## 148-18-CA

### 715 N BLOODWORTH STREET

## APPLICATION FOR A CERTIFICATE OF APPROPRIATENESS – STAFF REPORT

**Proposed Landscape Improvements  
For  
715 North Bloodworth Street  
Oakwood Historic District**

GARDENER BY NATURE LLC  
 DeVita-McClure / 715N. Bloodworth St.  
 Rear - Proposed new hardscape  
 9/12/18 JLT

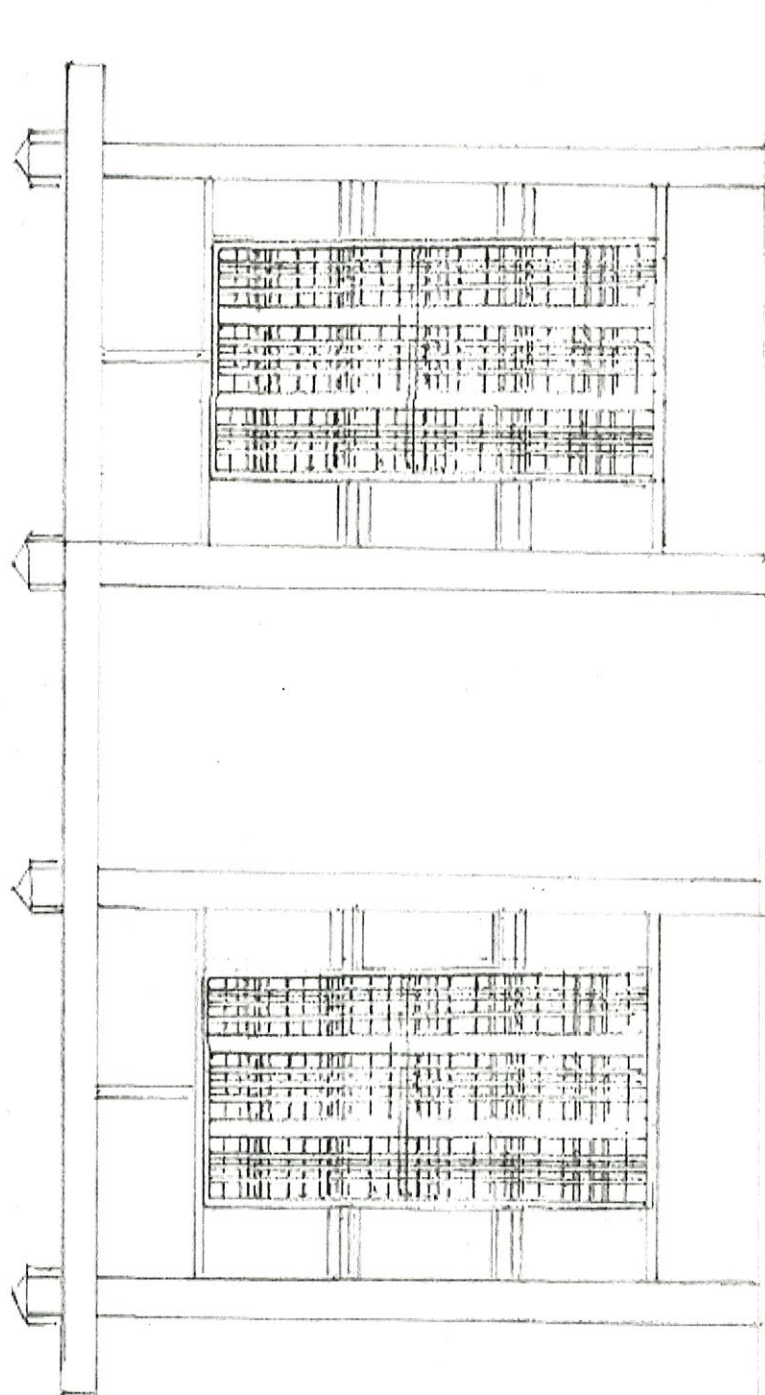
- 12\* The proposal includes a new 16' wide x 10' high pergola on the south side of the accessory building and a 6' wide x 6' deep x 10' high rose arbor in the center of the figure-eight walkway. A drawing of the pergola was provided, but drawings of the rose arbor were not. Pergolas and arbors are traditional rear yard landscape features.

17\* No evidence was provided to support the appropriateness of the height of the gate arbor and flanking panels, the rose arbor and the pergola.

Gardener by Nature LLC  
215 N Blossworth  
Entry Gate & fence at  
top of Driveway  
10/12/18 JLT

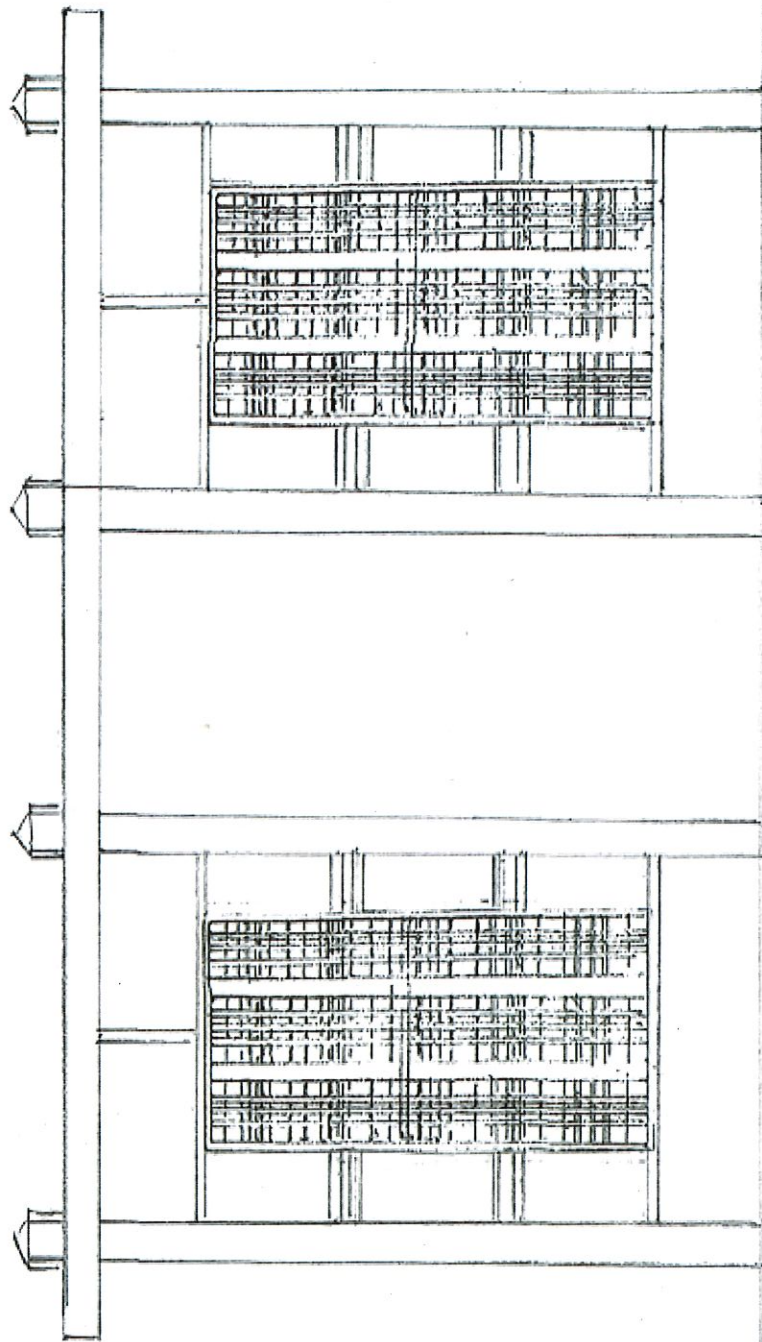
1. On page 27 you state that the fence will be replaced with a Craftsman-style fence, but I don't see any drawings or photos that illustrate what this means. Please provide either dimensioned drawings or color photos of the fence style.

HOUSE WALL

side panels and header feature trellis. catalina style pergola (also used in Pergola)

can surround and lower fences faced with square privacy trellis

Custom Iron Gate

The north and south boundary fences and can pad enclosure will be in this square trellis style, here seen on the adjoining property to the north. The height of these fences is not to exceed 42".

Gardener by Nature LLC  
Devita-McClure  
715 N Bloodworth  
Serpentine Brick Curb  
Elevation & Section  
10/2/18 JCT

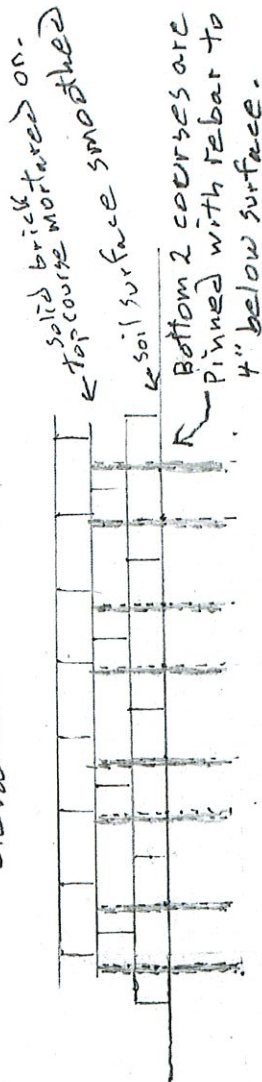
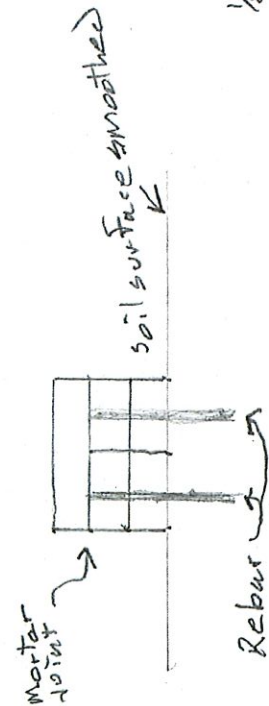
4. Please provide an elevation drawing for the 6" serpentine brick curb. A small detailed drawing will suffice rather than having to show the entire length of it. Will it be retaining soil behind it? If so, a section drawing will be required.

The plan calls for a 6" high 8" wide brick curbing passing at one point within about 5' from the tree.

-The curb will follow the existing surface contour, with excavation limited to leveling of significant bumps. The first 2 courses of brick are to be secured with rebar into existing soil.

-The only root disturbance will be hand cutting of surface roots crossing the line of the curb. Cuts are to be treated with a biotic based growth enhancement.

-2-3" of organic engineered topsoil is to be added between the curb and the tree to decrease compaction.

##### 5. Tree canopy impact.

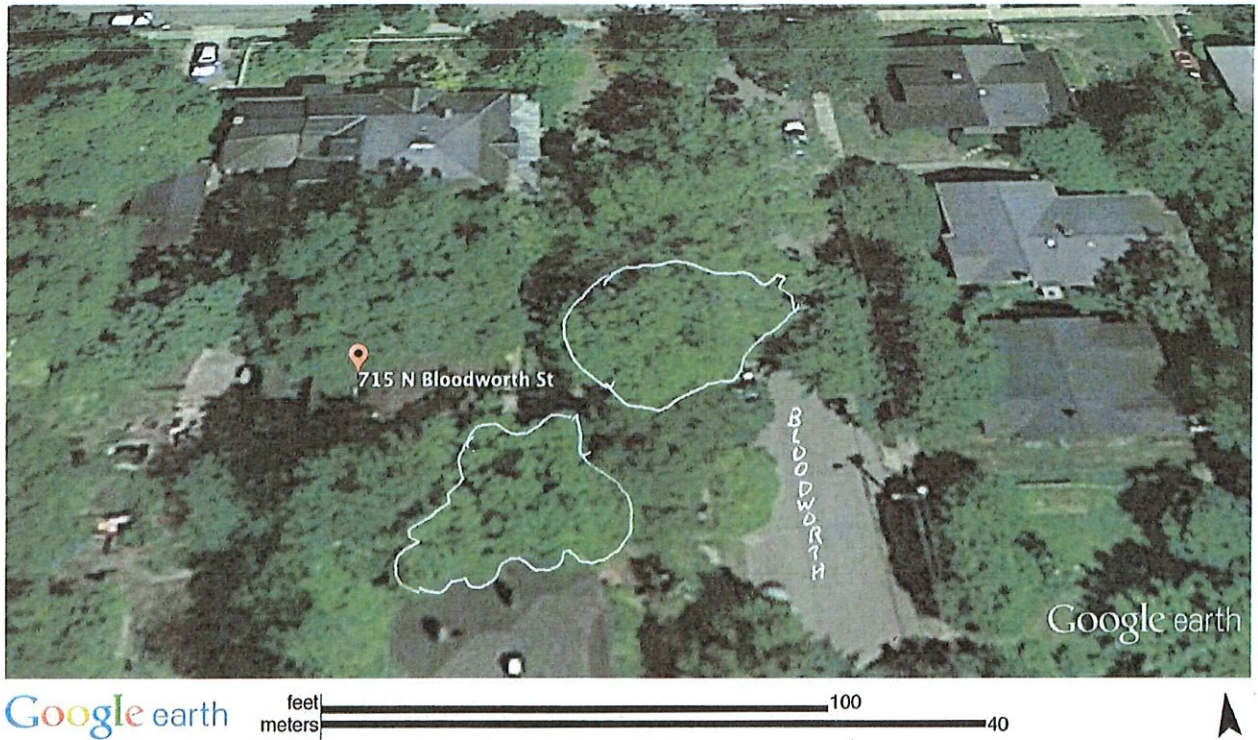
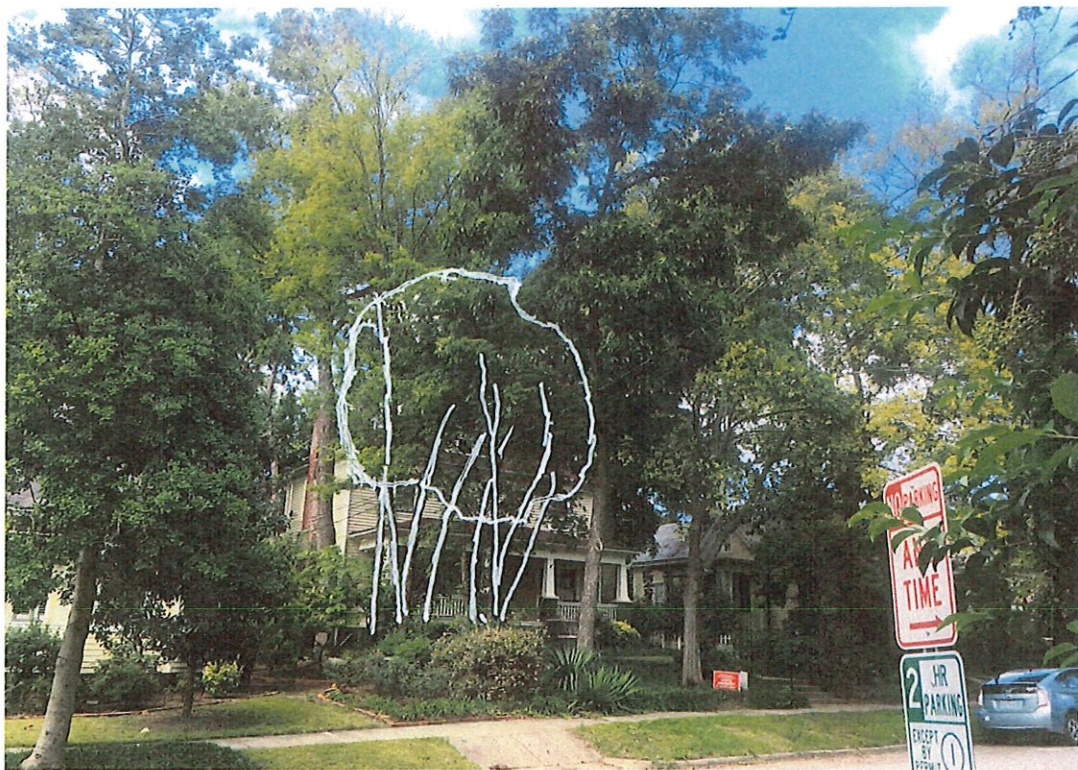
5. Please provide documentation showing the tree canopy for this property and those around it. A good example of this is shown on the attached application (044-18-CA) at 511 E Jones St. See pages 10-12 for an example of how to illustrate the existing canopy and the changes in removing the requested trees.

The canopy in this section of Oakwood is quite dense, as seen in these summer and winter aerial photos show. The plan proposes removal and replacement of 4 trees in the front yard. The canopy involved is highlighted here in white.

The large pecan highlighted here is in the path of proposed excavation for driveway improvements. This tree is to be replaced with another high canopy shade tree (options include native White Oak, Sugar Maple, or Black Gum) to be planted approx. 7' SW of the crown of this tree.

Highlighted here is a group of 3 'accidental' multi-stemmed wild hackberries growing along the south boundary. These young wild trees form a mid-level canopy beneath the higher canopy provided by 2 pecan trees and a beech tree which are to be preserved in the south section of the front yard. These trees are to be replaced with selected mid-level native flowering ornamental trees planted in nearby locations. An existing young red bud tree along this line is also to be preserved.
